SUBJECT: WOLF CREEK GENERATING STATION - STAFF ASSESSMENT OF INFORMATION PROVIDED PURSUANT TO TITLE 10 OF THE *CODE OF FEDERAL REGULATIONS* PART 50, SECTION 50.54(f), SEISMIC HAZARD REEVALUATIONS FOR RECOMMENDATION 2.1 OF THE NEAR-TERM TASK FORCE REVIEW OF INSIGHTS FROM THE FUKUSHIMA DAI-ICHI ACCIDENT (TAC NO. MF3755)

STAFF ASSESSMENT BY THE OFFICE OF NUCLEAR REACTOR REGULATION

RELATED TO SEISMIC HAZARD AND SCREENING REPORT

WOLF CREEK GENERATING STATION

Figure 3.3- 1Plot of Staff's and Licensee's Base Case Shear-Wave Velocity Profiles for the Wolf Creek site

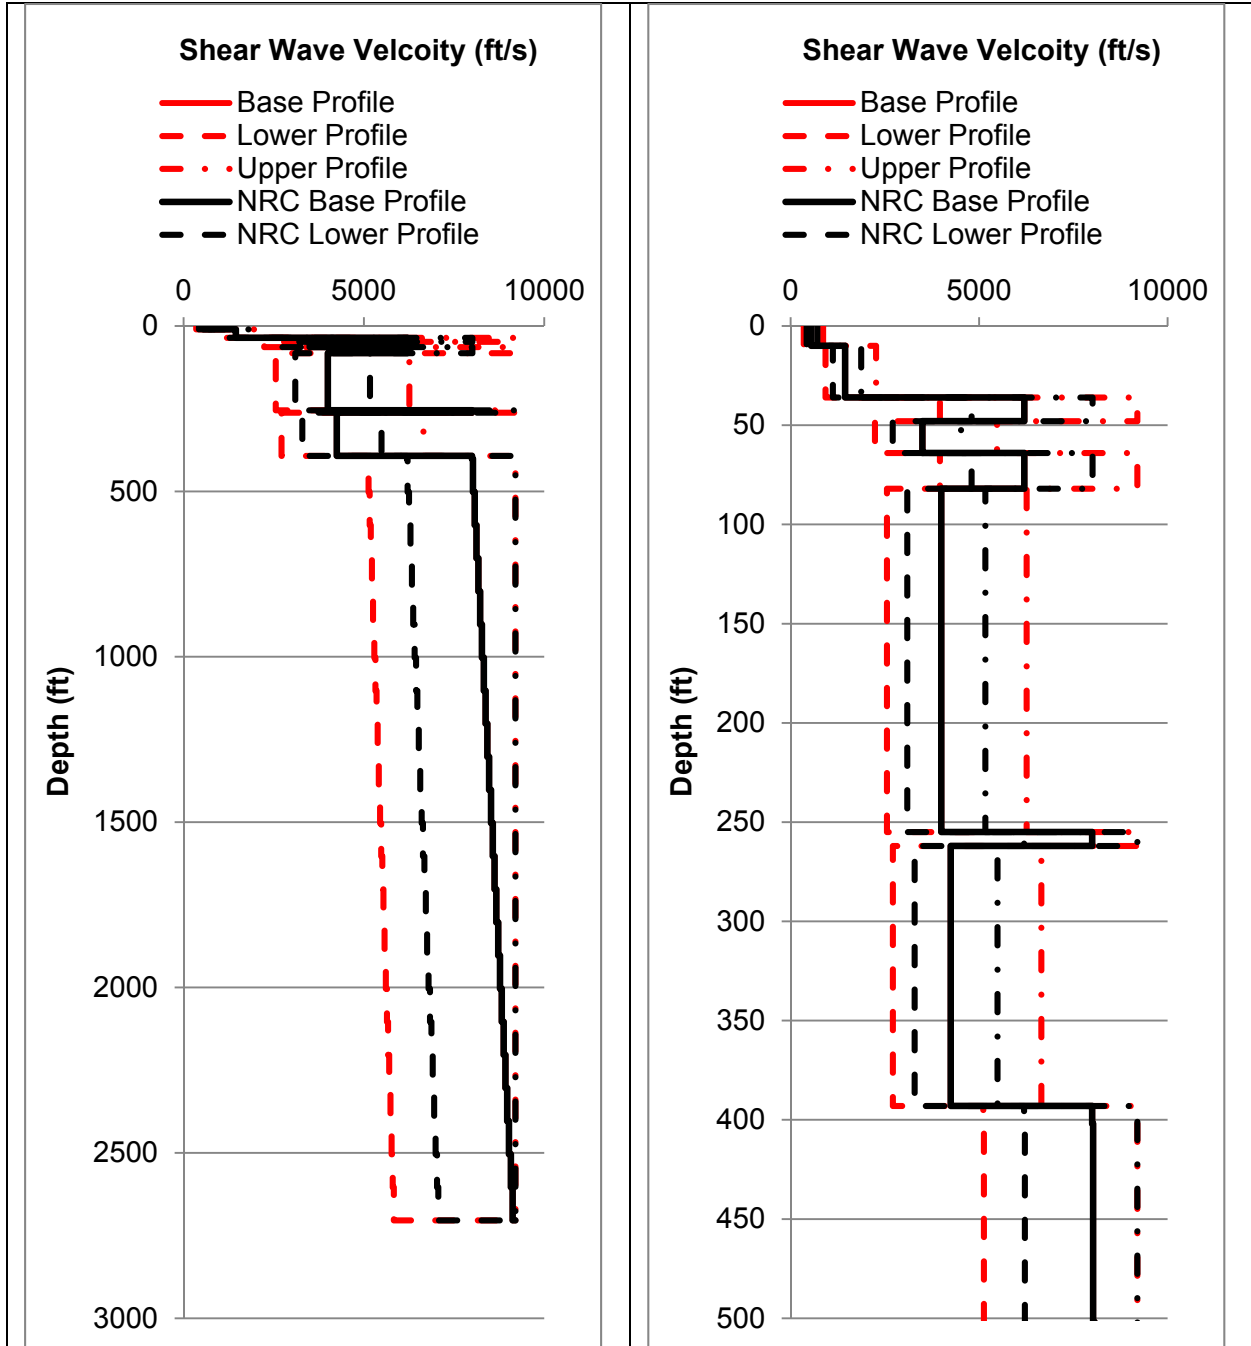
To characterize the subsurface geology, the licensee developed three site base case profiles. The middle, or best estimate, profile was developed using the specified shear wave velocities with a deepest velocity of 8,000 fps [2,438 m/s] and a gradient of 0.5 ft/s/ft, resulting in a base-case shear wave velocity of 9,075 fps [2,766 m/s] at a depth of 2,700 ft [823 m]. Upper and lower base case profiles were developed using a scale factor of 1.57 to reflect a natural log standard deviation of 0.35. Consistent with the SPID, to account for randomness in material properties across the plant site, the licensee stated that it randomized each of its three base case shear-wave velocity profiles. Figure 3.3-1 of this assessment shows the licensee's three base case shear-wave velocity profiles.

To confirm the licensee's site response analysis, the staff performed site response calculations for the Wolf Creek site. The staff independently developed three base case shear-wave velocity profiles from the information provided in USAR. The staff developed three separate profiles in order to capture the epistemic uncertainty in the modeled profiles. The USAR for Wolf Creek provides detailed information on the dynamic properties of the shallow site formations collected from numerous geophysical surveys including refraction, uphole compressional wave, uphole and crosshole shear wave, surface waves and ambient vibrations. Most of the shear wave velocities listed in the USAR were calculated from the compression wave velocities estimated from the refraction surveys. The NRC staff's base case shear-wave velocity profiles are shown along with the licensee's base case profiles in Figure 3.3-1 of this assessment. The staff's

shear wave velocity profiles are almost identical to those submitted by the licensee due to the detailed information in the USAR which is also presented in Table 2.3.2-1 of the SHSR.

Figure 3.3- 2 Plot Comparing the Staff's and the License's Median Amplification Functions and Uncertainties for two input loading levels for the Wolf Creek site

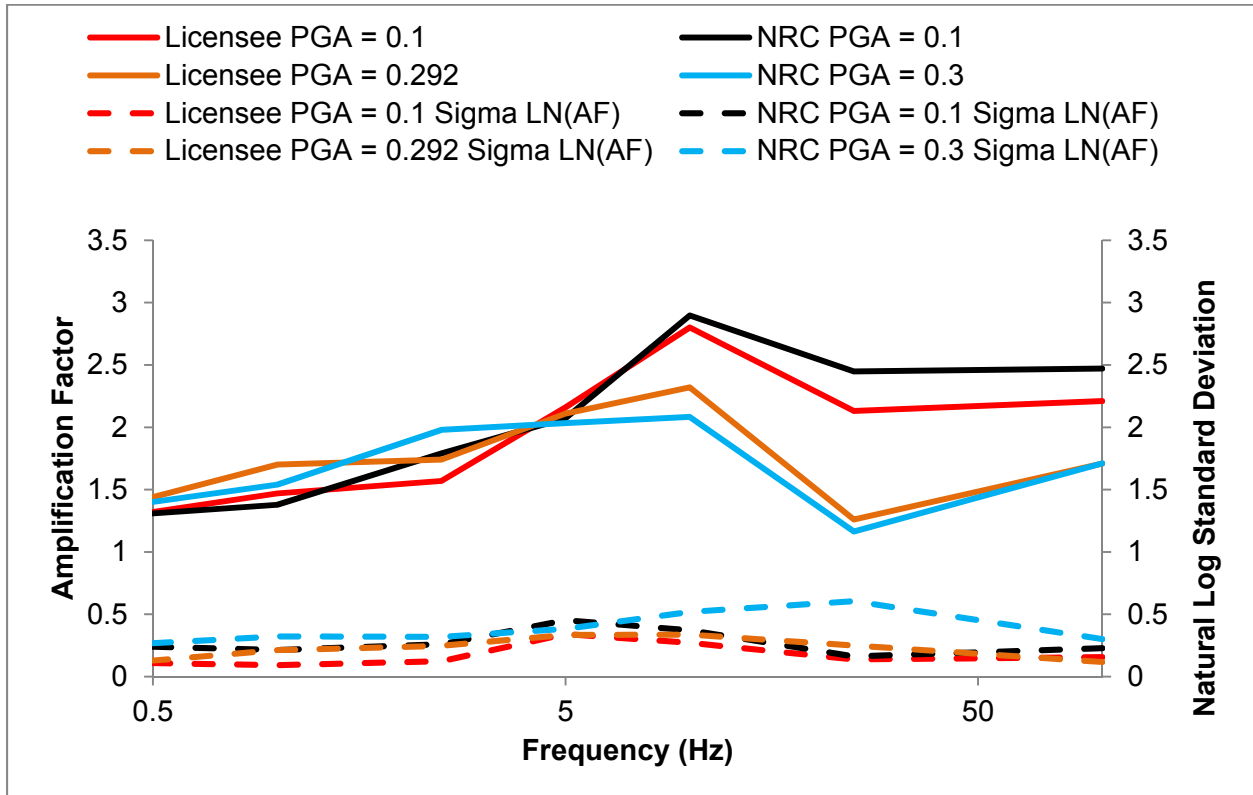
In order to calculate control point hazard curves for the Wolf Creek site, the staff developed median amplification functions for several different loading levels representing the possible hazard at the Wolf Creek site. The median site amplification and associated uncertainty for two separate loading levels are shown in Figure 3.3-2 of this assessment. A comparison of both the NRC staff's and licensee's site amplifications shows that they are similar in shape with minor differences at the higher frequency levels. These differences are due to small differences in the NRC staff's and licensee's velocity profiles in the rock layers and due to the wider range of uncertainty in kappa used by the NRC staff for its site response analysis. The licensee's and NRC staff's control point hazard curves resulting from the convolution of the site amplification with the PSHA rock hazard are shown in Figure 3.3-3 of this assessment. As shown in Figure 3.3-3, the licensee's and NRC staff's control point hazard curves are nearly identical.

Figure 3.4-1 Comparison of the Staff's GMRS with Licensee's GMRS and the SSEs for the Wolf Creek Site (Powerblock and Non-Powerblock SSE (used for Screening))

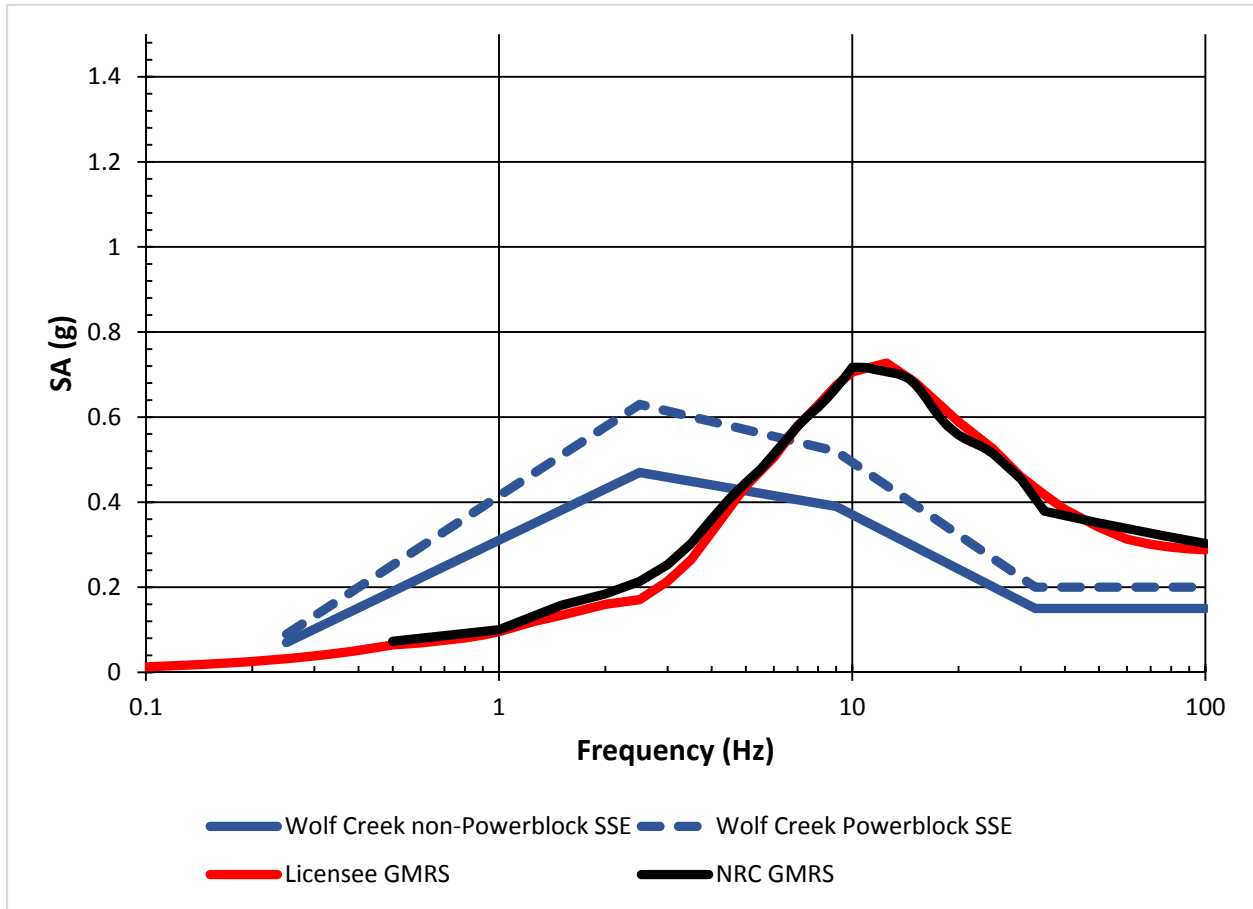
The NRC staff independently calculated the 10^{-4} and 10^{-5} UHRS using the results of its confirmatory PSHA and site response analyses, as described in Sections 3.2 and 3.3 of this staff assessment, respectively. Figure 3.4-1 of this assessment shows a comparison of the GMRS determined by the licensee to that determined by the NRC staff. As shown, the licensee's and NRC staff's GMRS are very similar.

The NRC staff confirms that the licensee used the present-day guidance and methodology outlined in RG 1.208 and the SPID to calculate the horizontal GMRS, as requested in the 50.54(f) letter. The NRC staff performed both a PSHA and site response confirmatory analysis and achieved results consistent with the licensee's horizontal GMRS. As such, the NRC staff concludes that the GMRS determined by the licensee adequately characterizes the reevaluated hazard for the Wolf Creek site. Therefore, this GMRS is suitable for use in subsequent evaluations and confirmations, as needed, for the response to the 50.54(f) letter.
